Re: Munjoy South Project

A preliminary check of your as yet incomplete plans of the above project reveals the following omissions or discrepancies as to City of Portland Building Code requirements as follows:

A.P.- Munjoy South Project

Permit to construct 36 multi-family dwelling units as per plans and specifications at the above named location is being issued subject to compliance with the following:

PROPOSED BATTENS - SEALING GABLE JOINTS

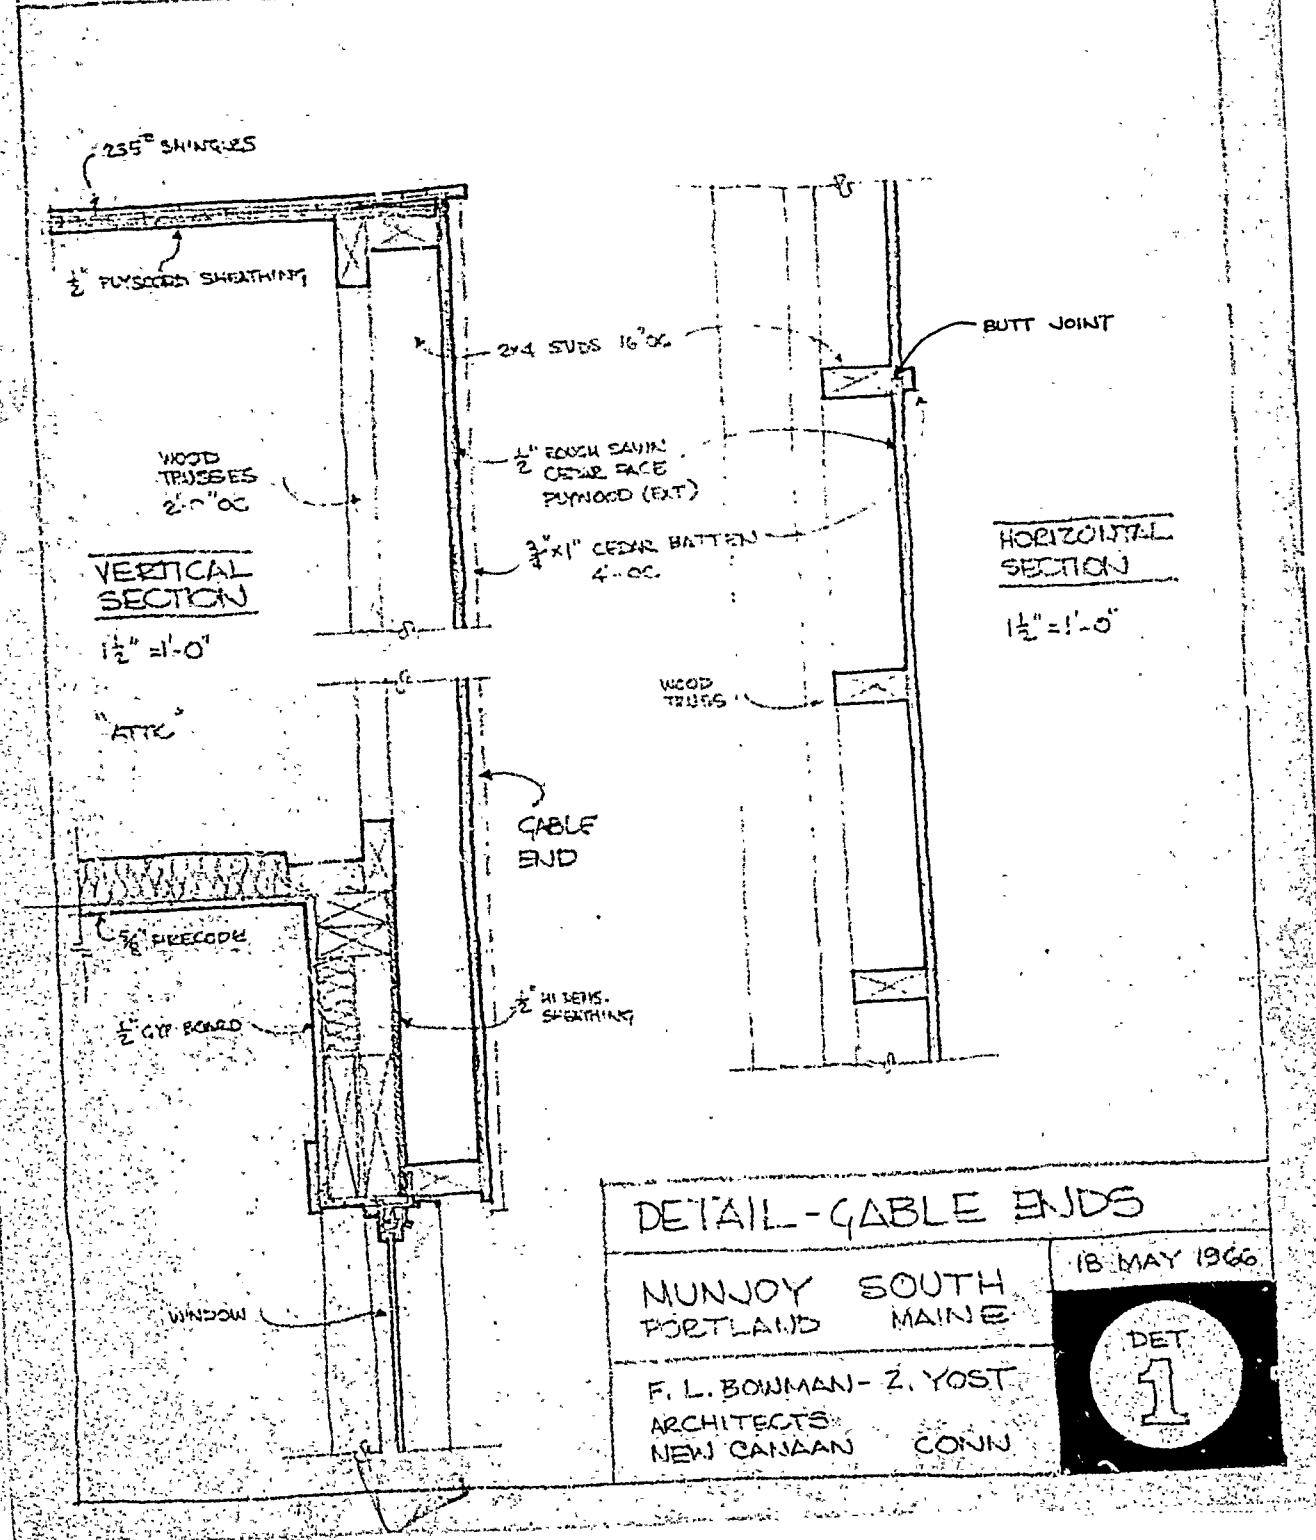
In response to our recent telephone conversation, I am enclosing our sketch dated 18 May, showing a suggested revision of the gable end detail.

Our proposal is to butt joint the exterior plywood, and cover it with a batten. All joints are nailed to 2 x 4 studs for their entire length; there are no horizontal joints, as we plan to use extra-length sheets of plywood where required.
